PLANNING COMMISSION REPORT

MEETING DATE: November 10, 2004

W Hotel Scottsdale - 22-ZN-2004 & 19-AB-2004

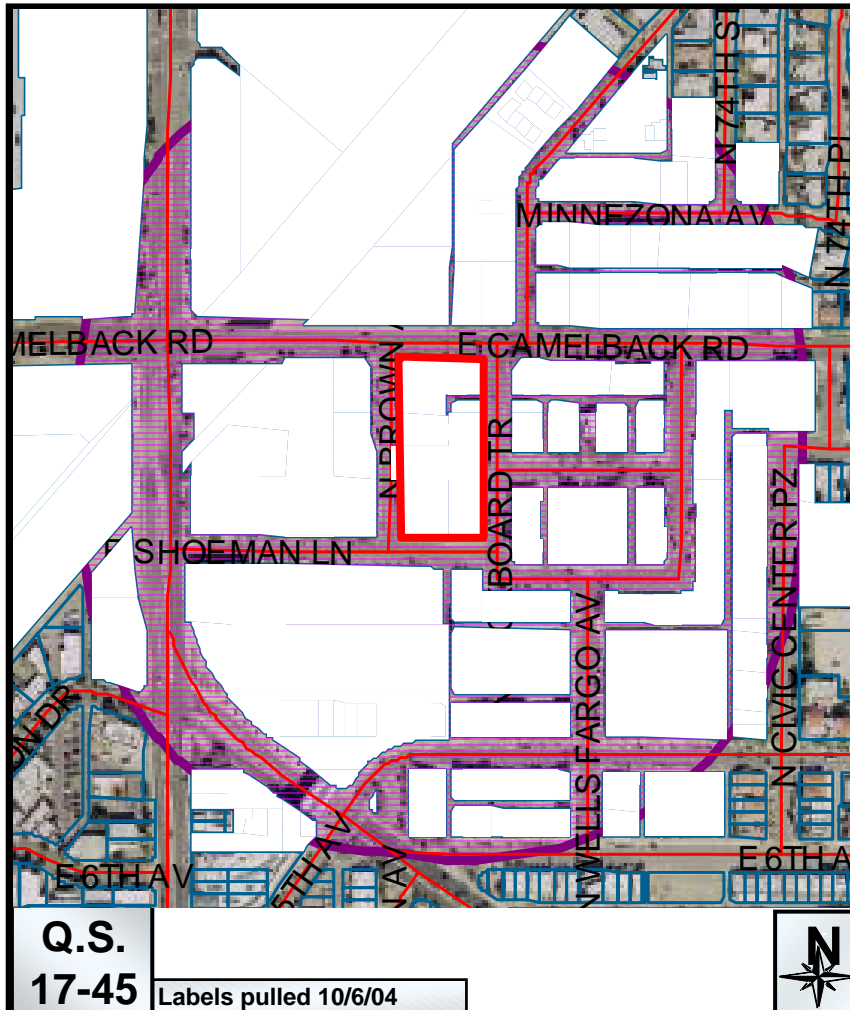
Staff Concerns/Comments:

- The proposed site driveway on Camelback Road does not meet minimum intersection spacing criteria for minor arterial streets. The driveway is located approximately 135 feet from the adjacent Buckboard Trail and Brown Avenue intersections.
- The development plan should provide enhanced pedestrian connections to the adjacent land uses.
